# MARC4 Microcontroller Enhancement Report

**Enhancement  
Report**

4668D-4BMCU-02/08

**Figure 2-3.** Enhanced Reset Function

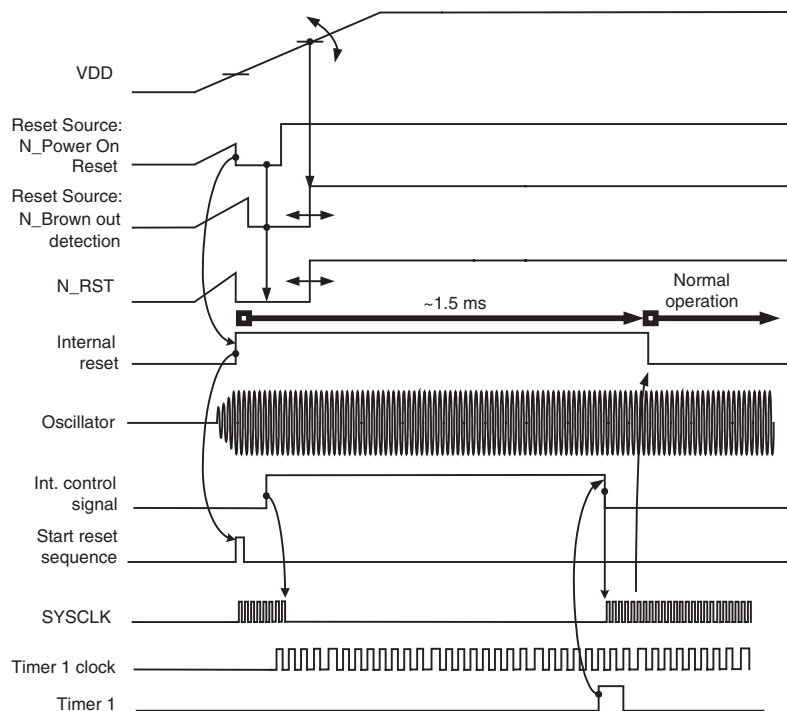
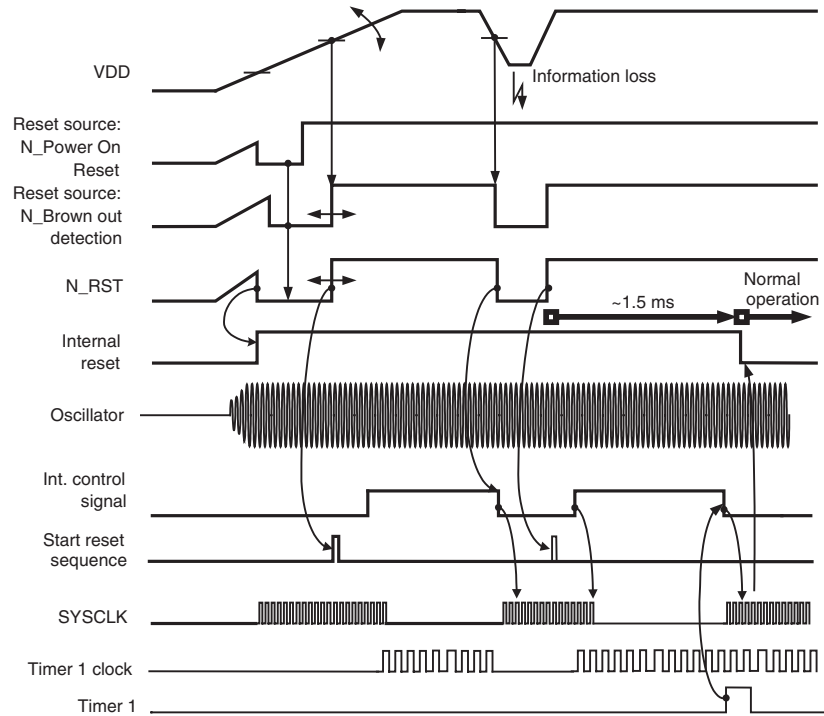
1. The starting point of the reset sequence is moved to the rising edge of the  $N\_RST$  signal ensuring that the initialization starts operating under proper VDD conditions.
2. The  $N\_RST$  signal always restarts the reset sequence. This is the same condition as for power on. All flip-flops and registers that may have lost their information during the voltage drop are initialized again and the circuit starts operating properly.

This enhancement is fully compatible with the former normal reset operation and does not require any changes to either the software nor the application board for parts already in production.

The modification is performed by a minor change of the internal wiring (metal\_mask) only.

**Figure 2-2.** Reset Function Due to Bouncing

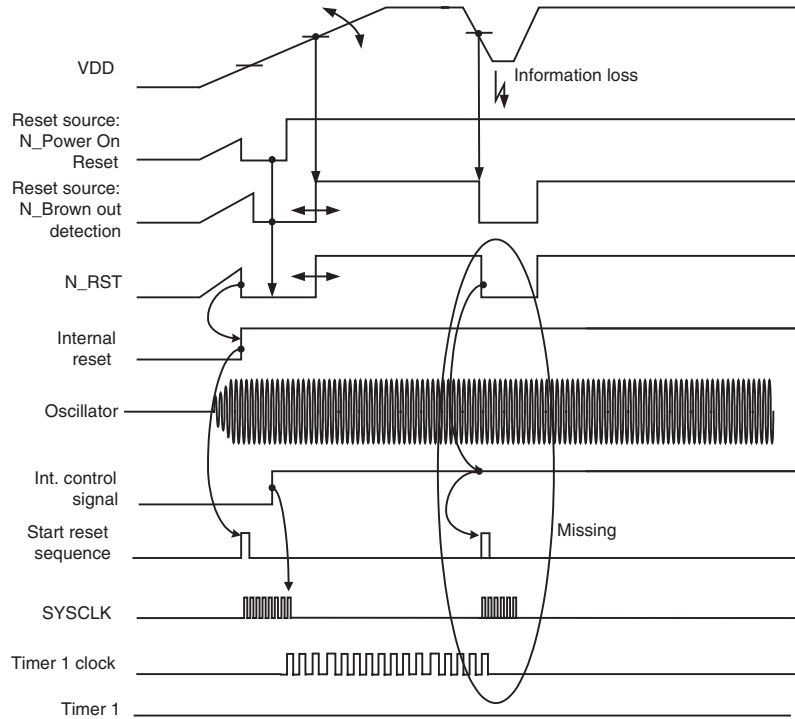
In case of a voltage drop below ~1 V during the reset sequence, it is possible that some already initialized flip-flops may lose their information. As the internal reset cannot be interrupted the reset sequence does not restart (circled in Figure 2-2) and the flip-flops concerned will not be initialized again. If this happens to the flip-flop responsible for the clock selection of timer 1, it could lead to a deadlock or lock-up condition where the circuit is not able to finish the reset and start operating.

**Figure 2-4.** Enhanced Reset Function (Low Power)

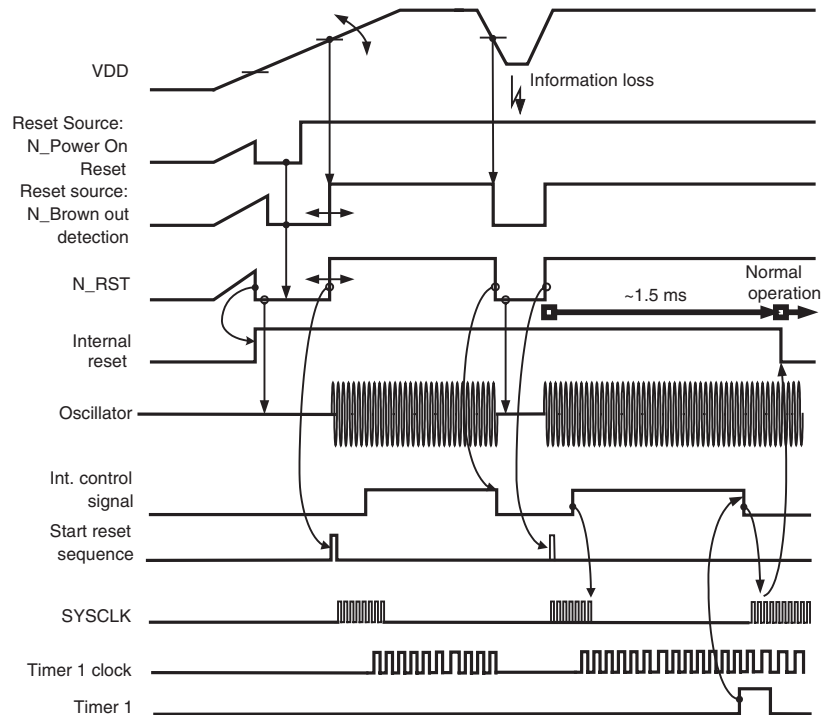
1. The starting point of the reset sequence is moved to the rising edge of the  $N\_RST$  signal, ensuring that the initialization starts operating under proper VDD conditions.
2. The  $N\_RST$  signal always restarts the reset sequence. This is the same condition as for power on. All flip-flops and registers that may have lost their information during the voltage drop are initialized again and the circuit starts operating properly.
3. Reduce the power consumption as long as the supply voltage stays below the operating range. This is performed by stopping the oscillator (and all derived clock signals) while a reset condition is active ( $N\_RST = \text{low}$ ).

This enhancement is fully compatible to the former normal reset operation and does not require any changes to either the software or the application board for parts already in production.

The modification is performed by a minor change of the internal wiring (metal\_masks, via\_mask) only.

**Figure 5-3.** Special Conditions

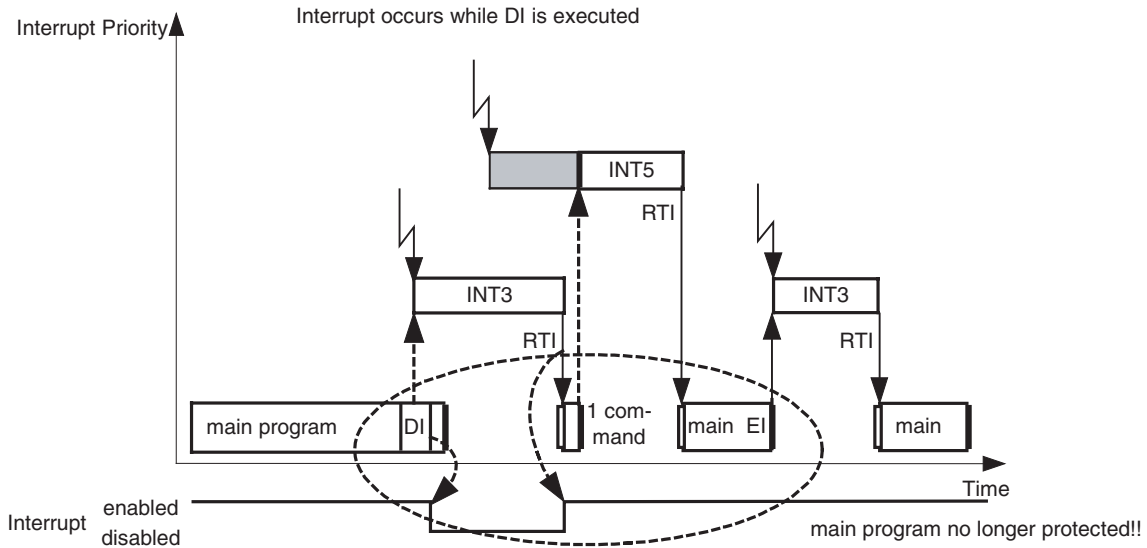
If an interrupt occurs during a special clock phase while the DI instruction is being executed, the circuit acknowledges the interrupt, jumps into the interrupt service routine and at the same time finishes the DI instruction. Now the interrupt enable flag is reset (disable interrupt) and further interrupts are stored in the pending register. Leaving the service routine, the RTI (return from interrupt) sets the interrupt enable flag (enable interrupt). Program execution now continues at the instruction following the DI, but with interrupts enabled. If another interrupt occurs the DI no longer prevents the program from being interrupted.

The only way to ensure proper DI execution is to test that DI has been executed. This is best performed in a loop, until the interrupt enable flag is reset. Now, if the DI is interrupted the program returns into the loop, executes DI again and then continues with the program to be protected.

In addition to the above described safe method, there is another way to drastically reduce the probability of a DI-malfunction. Just use 2 consecutive DI commands instead of only one. If the first one is disturbed by an interrupt, the return from interrupt will land at the second DI and continue normal program execution.

**Figure 5-4.** Enhanced Interrupt Execution

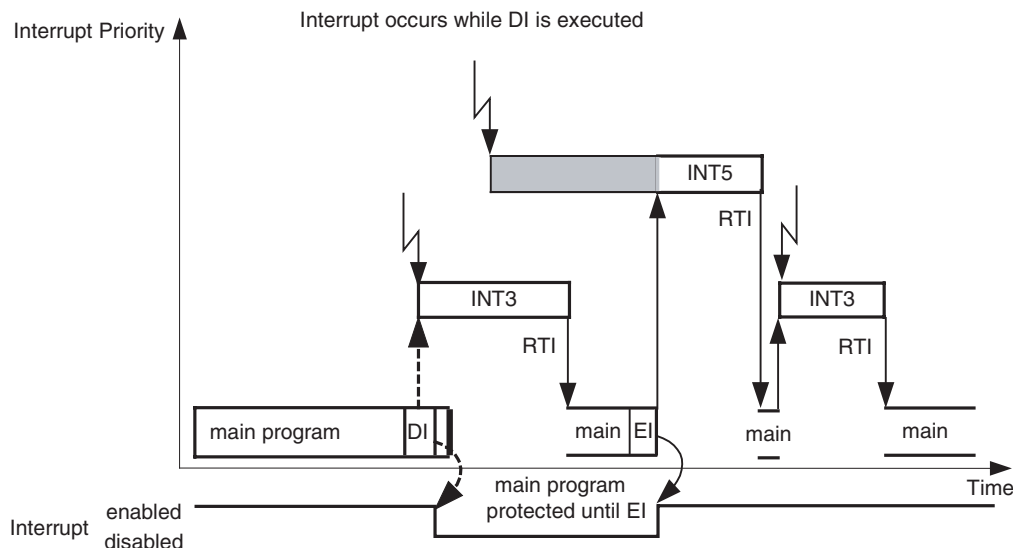
The enhancement introduced to the circuit is as follows. Due to the fact that it is not the DI itself that causes possible problems but the interrupt that follows after the return from interrupt (RTI), we modified the function of the RTI instruction. From now on the RTI not longer perform an EI (enable interrupt).

When entering an interrupt service routine normally the interrupt is enabled. Saving the CCR keeps this information. Restoring it at the end of the routine enables the interrupt again. There is no need to perform an additional EI by the RTI instruction.

In case of an interrupt occurring simultaneously to the DI the interrupt flag has the status “disable” when the service routine is entered. This information is saved and restored just before the RTI. Now the interrupt is disabled again and the modified RTI does not enable it. The program to be protected still is protected.
